APPEAL SUMMARY

Appeal ID: 26448	Project Address: 1520 NW 17th Ave
Hearing Date: 1/26/22	Appellant Name: Michael Barrett
Case No.: B-007	Appellant Phone: 5419689374
Appeal Type: Building	Plans Examiner/Inspector: Maureen McCafferty
Project Type: commercial	Stories: 1 Occupancy: B Construction Type: II-B
Building/Business Name: Bemis	Fire Sprinklers: No
Appeal Involves: Alteration of an existing structure LUR or Permit Application No.: 21-106725-CO	
Plan Submitted Option: pdf [File 1]	Proposed use: Creative Office

APPEAL INFORMATION SHEET

PLUMBING CALCULATIONS (2902.1)

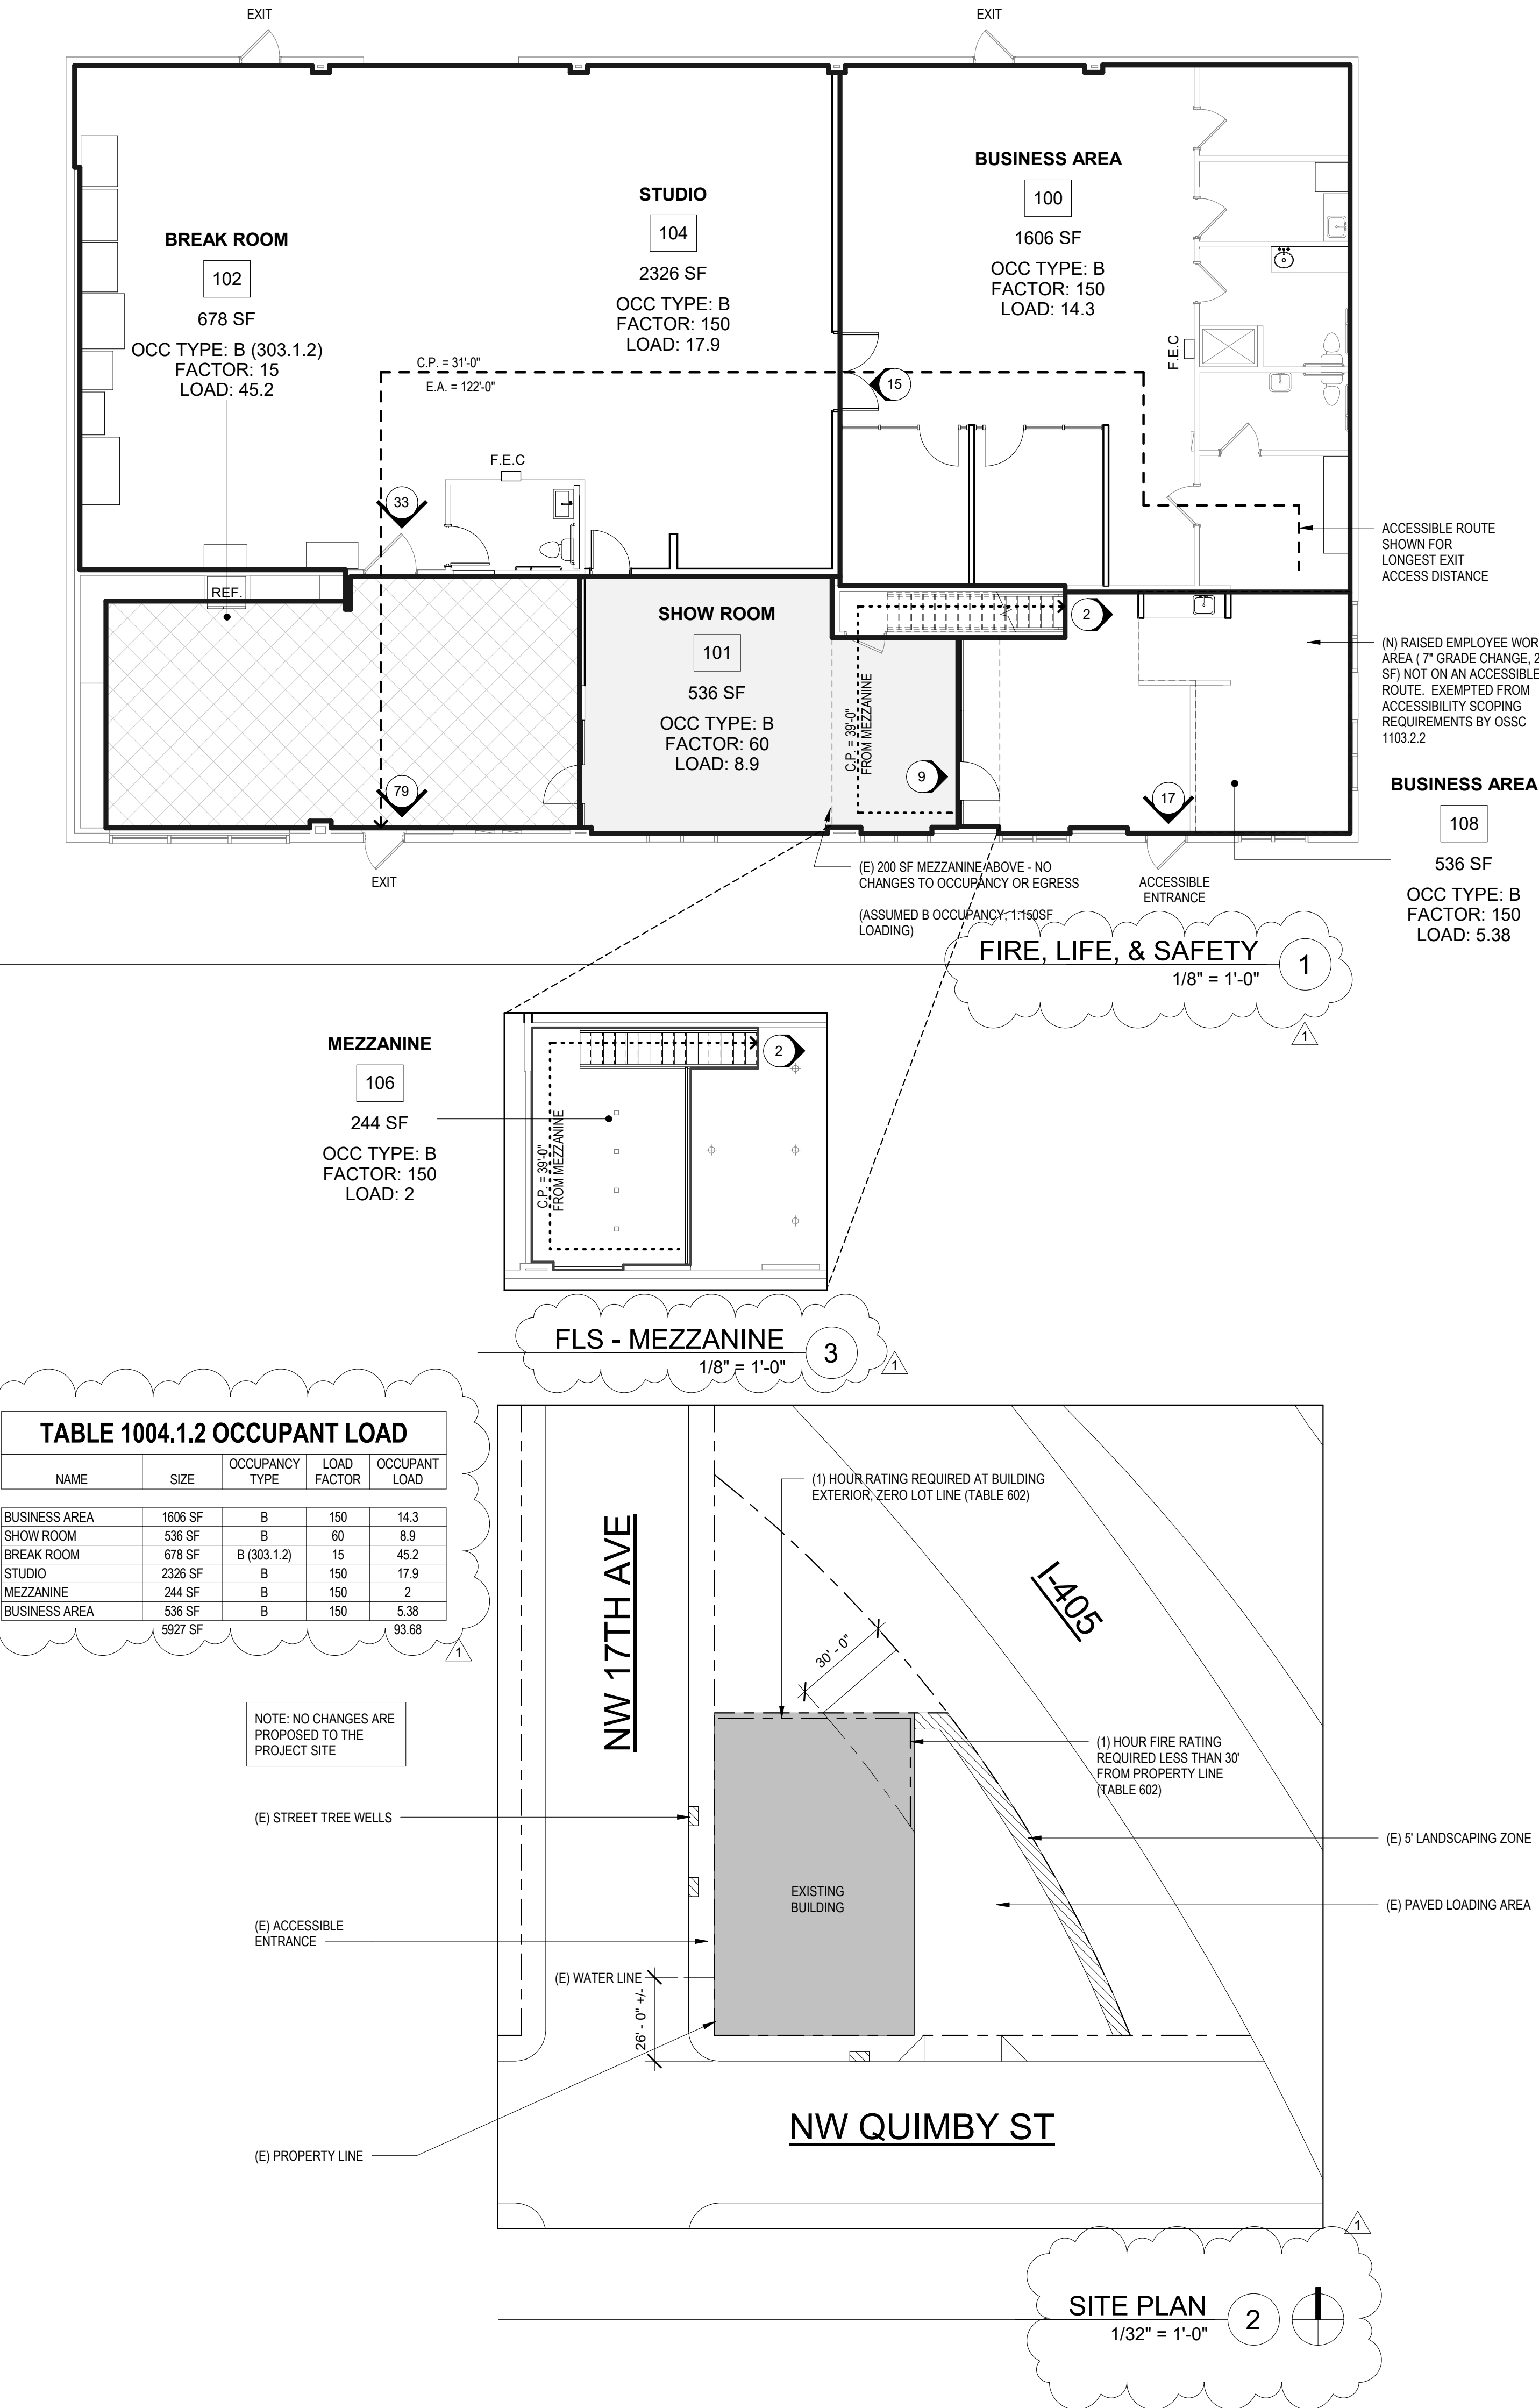
Code Modification or Alternate Requested Allow total occupant load to be counted as gender-neutral when determining plumbing calculations if single-user restrooms are provided.

Proposed Design The project provides three separate single-user restrooms with a water closet and lavatory for building occupants. Operationally, these restrooms are considered gender-neutral and open to all occupants regardless of gender identity.

The design proposes to not divide occupants based on gender and to meet the water closet and lavatory requirements per OSSC 2902.1.1 and to treat the total occupant load as gender neutral occupants. Compliance with Table 2902.1 will meet the more restrictive column, with gender neutral facilities provided through single-user, gender neutral, restrooms.

The project meets the fixture counts for a single gender occupant load (3 water closets for men or women exclusively). By viewing the total occupant load as also gender-neutral and providing gender-neutral facilities through single-occupant restrooms, the project meets the same criteria established for a single gender.

Code Modification or Alternate Requested	Non-simultaneous use for plumbing fixture counts between break room and business areas. Acceptance of an alternate method to determine plumbing fixtures under OSSC 2901.2.
---	--

Proposed Design	Exempt the occupant load within the break room for the use in calculating plumbing fixture counts only. Egress requires and Title 24.85 thresholds to use the full occupant load.
------------------------	---

1. Reduction in the minimum required number of plumbing fixtures based on calculation as non-gendered: Granted provided 2 of the toilet rooms are fully accessible.

2. Reduction in the minimum required number of plumbing fixtures based non non-simultaneous use: Denied. Proposal does not provide equivalent sanitary protection.
